Project	IEEE 802.16 Broadband Wireless Access Working Group < http://ieee802.org/16 >	
Title	Frame Structure to Support Multi-hop Relay Operation	
Date Submitted	2007-01-08	
Source(s)	<p>Wendy C Wong wendy.c.wong@intel.com Jerry Sydir jerry.sydir@intel.com Hannah Hyunjeong Lee Kerstin Johnsson</p> <p>Roger Peterson r.peterson@motorola.com Eugene Visotsky Masahito Asa asa@motorola.com</p> <p>Fang-Ching Ren frank_ren@itri.org.tw I-Kang Fu IKFu@ITRI.ORG.TW</p>	<p>Intel Corporation 2200 Mission College Blvd., Santa Clara, CA 95054, USA</p> <p>ola Labs E. Algonquin Road, Schaumburg, IL 60196 Motorola Japan Ltd., 3-20-1 Minamiazabu, Minatoku, Tokyo, 106-8573, Japan</p> <p>National Chiao Tung University/Industrial Technology Research Institute 1001 Ta Hsueh Road, Hsinchu, Taiwan 300, ROC</p>
		Motor 1301
Re:	This is a response to the call for proposals 80216j-06_034.pdf.	
Abstract	This contribution propose a frame structure to support multi-hop (≥ 2 hops) relay operation.

Frame Structure to Support Multi-hop Relay Operation

Figure xxx Example of minimum configuration for a multi-hop, in-band non-transparent relay frame structure

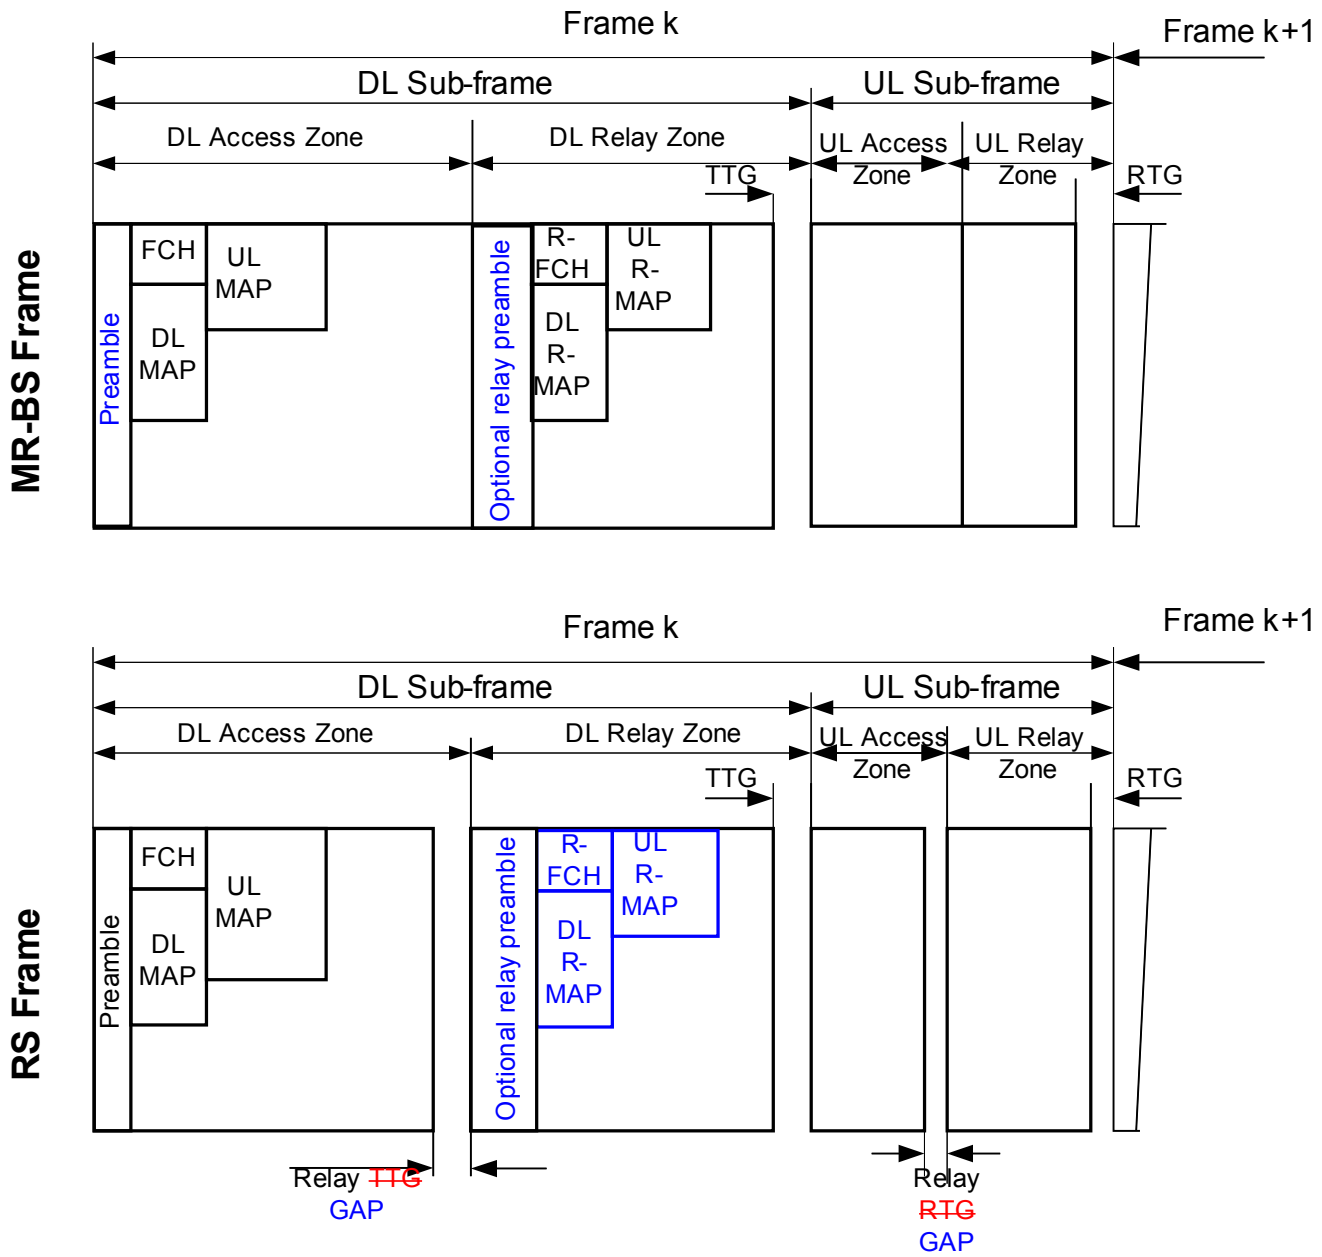
8.4.4.7.2.1 MR-BS frame structure

For the TDD mode, an example of the MR-BS frame structure is shown in Figure xxx.

Each MR-BS frame begins with a preamble followed by an FCH and the DL MAP and possibly UL MAP. The DL sub-frame shall include at least one DL Access Zone and may include one or more DL Relay_Zones. **The MR-BS shall be assigned to transmit or be idle in each of the DL Relay_Zones.** The UL sub-frame shall include at least one UL Access Zones and it may include one or more UL Relay_Zones. **The MR-BS shall be assigned to receive or be idle in each of the UL Relay_Zones.** In each frame, the TTG shall be inserted between the DL sub-frame and the UL sub-frame. The RTG shall be inserted at the end of each frame. In the DL Access Zone, the subchannel allocation, the FCH transmission, and the FCH shall be defined as in Section 8.4.4.2.

The DL Relay_Zone **may begin with a relay preamble** and shall include an R-FCH and an R-MAP. **The MR-BS may transmit a relay preamble and shall transmit R-FCH, and R-MAP in those DL Relay_Zones in which it is assigned to transmit.** The structure of the relay preamble shall be the same as specified in section 8.4.6.1.1. **The set of preamble modulation sequences transmitted in the relay preamble shall be different from the preamble modulation sequences transmitted in the Frame Start Preamble.** In the DL Relay_Zone, the subchannel allocation may be the same as that in the DL Access Zone. The R-FCH may be the same as the FCH in the DL Access Zone. Other attributes of the MR-BS frame and the RS frame such as transition between modulation and coding, presence of multiple zones, may be the same as those described in 8.4.4.2.

Figure xxx Example of an M frame MR-BS and RS kth Super-Frames

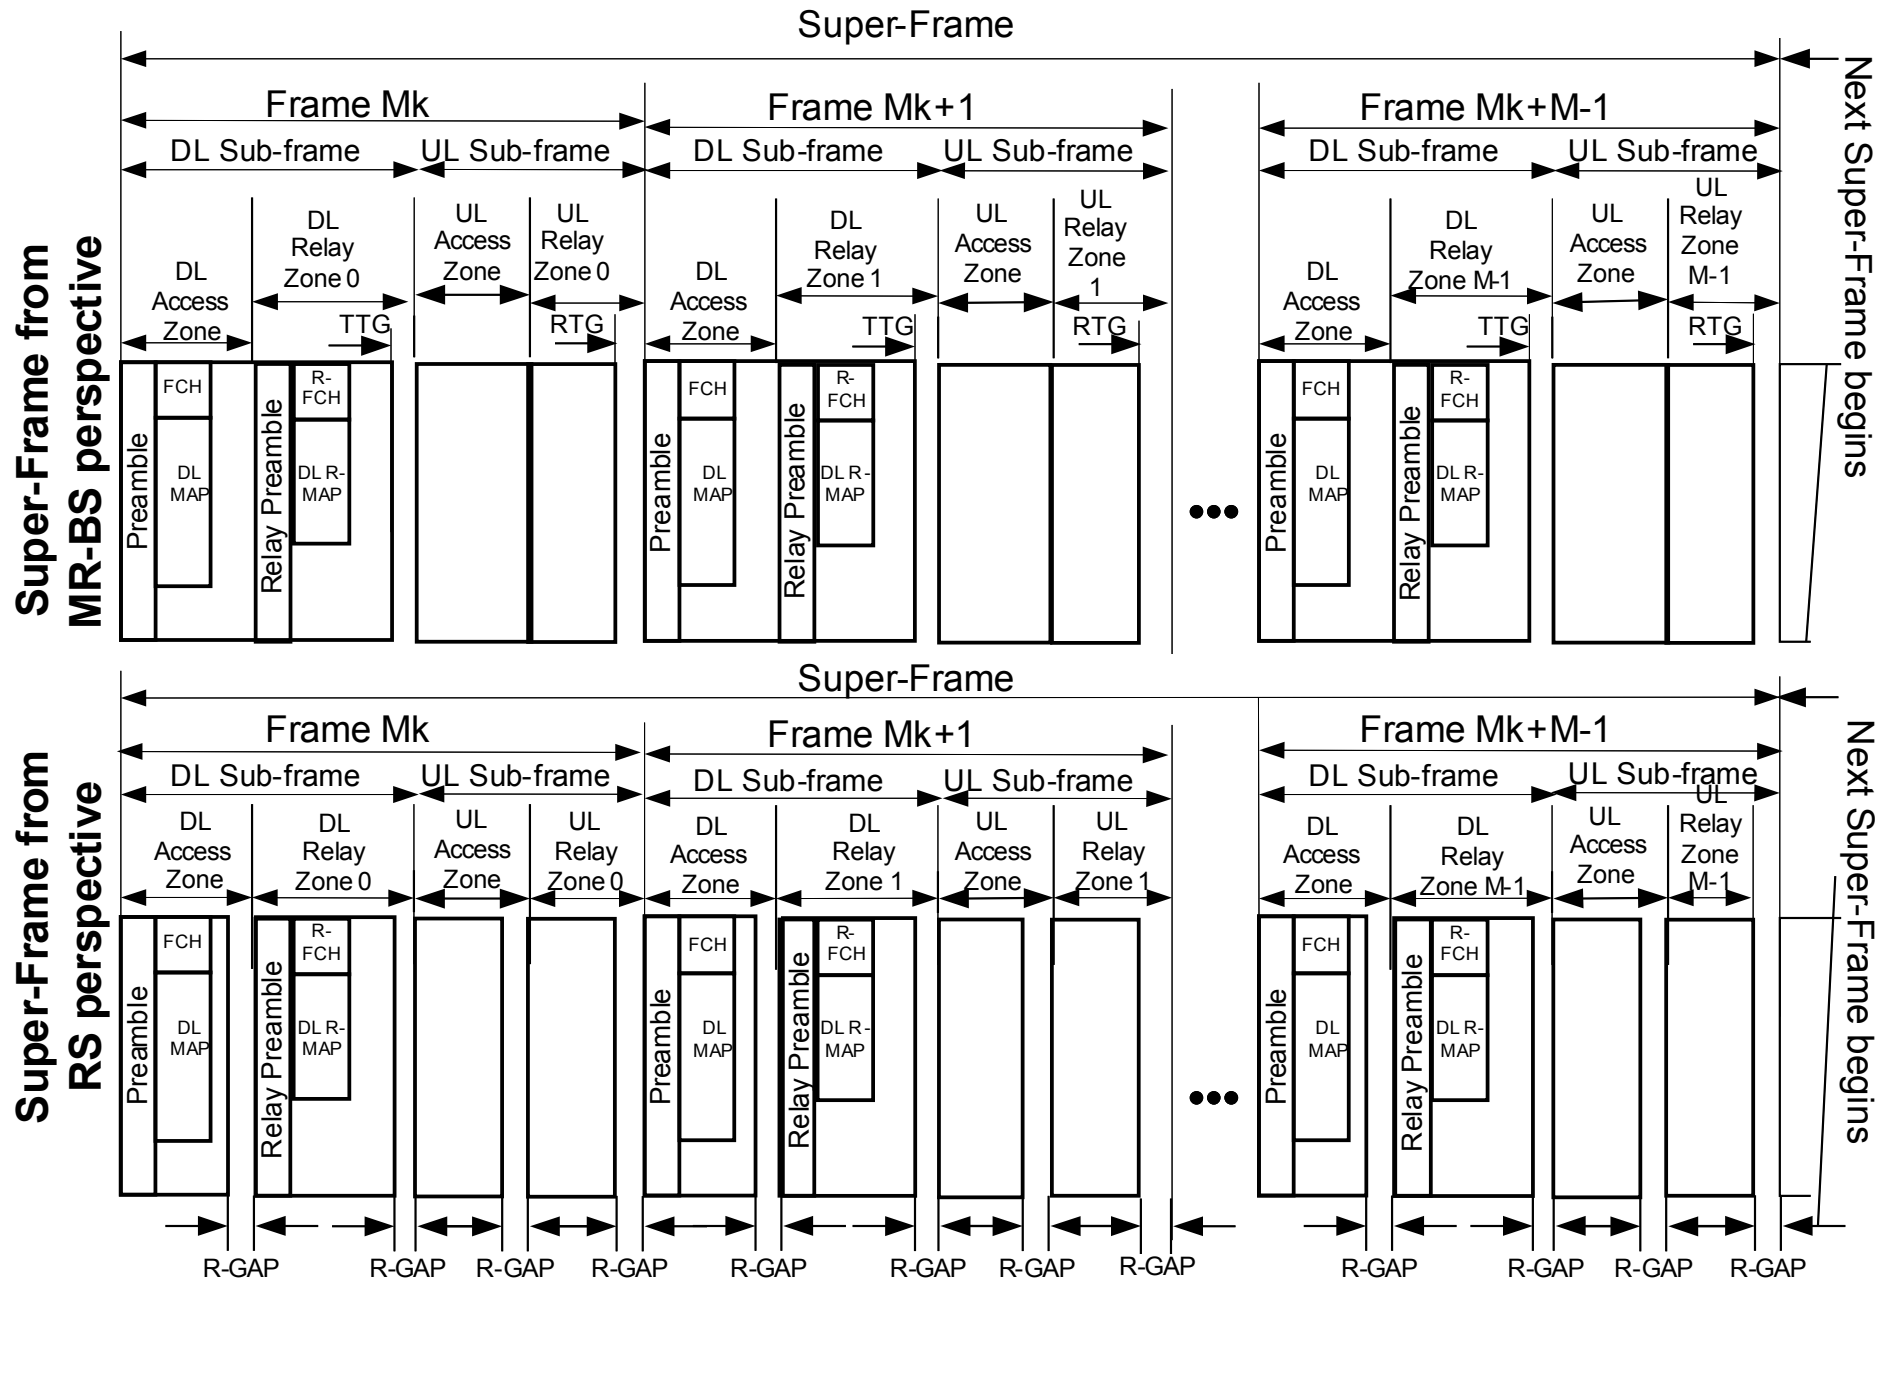
8.4.4.7.2.3 Super-frame structure to support multi-hop (≥ 2 hops)

An example of an MR-BS and an RS super-frame is shown in figure xxxx. This super-frame structure collapse back to the frame structure proposed in 8.4.4.7.2.1 and 8.4.4.7.2.2 when M is set to 1. One or more MR-BS frames may be grouped into an MR-BS super-frame. The number of MR-BS frames that make up an MR-BS super-frame shall be configurable. One or more RS frames may be grouped into an RS super-frame. The number of RS frames that make up an RS super-frame shall be configurable. The number of MR-BS frames that make up an MR-BS super-frame shall be the same as the number of RS frames that make up an RS super-frame.

The DL Relay_Zones within the MR-BS frames that make up an MR-BS super-frame shall be uniquely identified within the super-frame. When super-frames are used, the MR-BS is assigned to either transmit or be idle in each of the DL Relay_Zones in the MR-BS super-frame.

The UL Relay_Zones within the RS frames that make up an RS super-frame shall be uniquely identified within the super-frame. When super-frames are used, an RS is assigned to either transmit, receive or be idle in each of the UL Relay_Zones in the RS super-frame.
